Informal document GRPE-85-04-Rev.1 to amend
ECE/TRANS/WP.29/GRPE/2021/17
85th GRPE, 11-14 Jan-2021, Agenda item 4
Proposed updates to GRPE/2021/17 are shown via tracked
changes.

Particle Measurement Programme (PMP)

Proposal for a new Consolidated Resolution concerning Exhaust Ultra-Fine Particle Number Measurement For Heavy Duty Engines

Proposal for a Consolidated Resolution on the exhaust ultra-fine particle number measurement for heavy duty engines

Examples of different SPN sampling configurations:

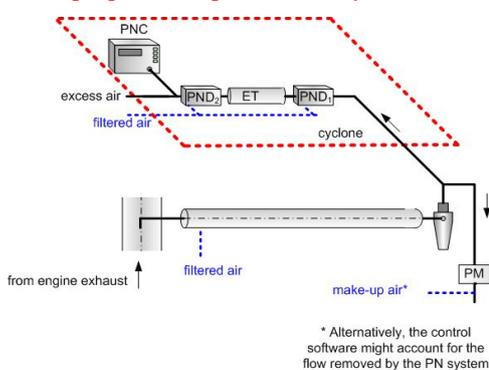
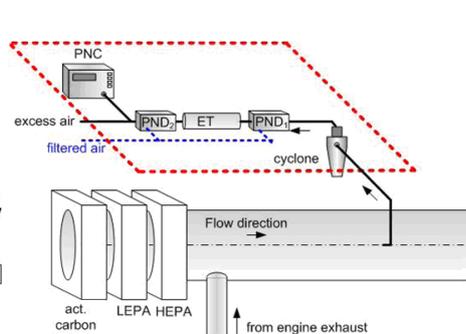
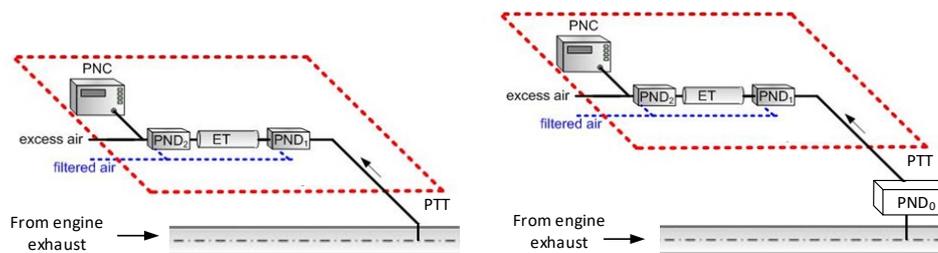
19. The modifications introduced to UN Regulation No. 49 aims mainly at introducing as an alternative option the possibility to measure solid particle number (SPN) directly from the tailpipe with fixed dilution, in addition to the currently allowed options of measuring from a proportional partial flow system or the full dilution tunnel.

Sampling line	When sampling directly from the tailpipe the residence time until the pre-diluter or the VPR shall be ≤ 1 seconds. The tubing shall be heated at ≥150°C if ≥10 cm, otherwise only insulated. <u>Any unheated parts shall be <10 cm. Good engineering judgment should be applied to minimise particle losses and insulate unheated parts.</u>	Reduced residence time, hot sampling line to avoid condensation and minimise particle losses

Figure 21
Schematic of recommended particle sampling system – Tailpipe sampling (i) without pre-diluter; (ii) with pre-diluter.

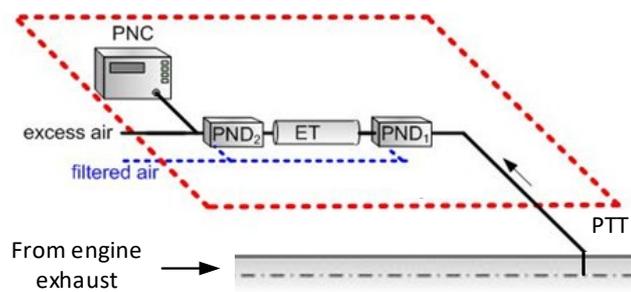
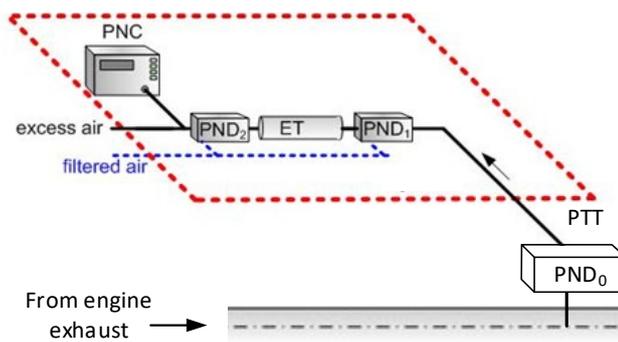
A cold or hot pre-diluter may be located at the end of the particle sampling probe and in front of the PTT. A fixed dilution ratio >5:1 shall be applied to the cold or hot dilution stage. Cold dilution is defined as a dilution with (unheated) dilution air and/or diluter temperature $\geq 20^{\circ}\text{C}$. Indicators of whether temperatures (if applicable) and dilutions are at their correct operating ranges shall be provided.
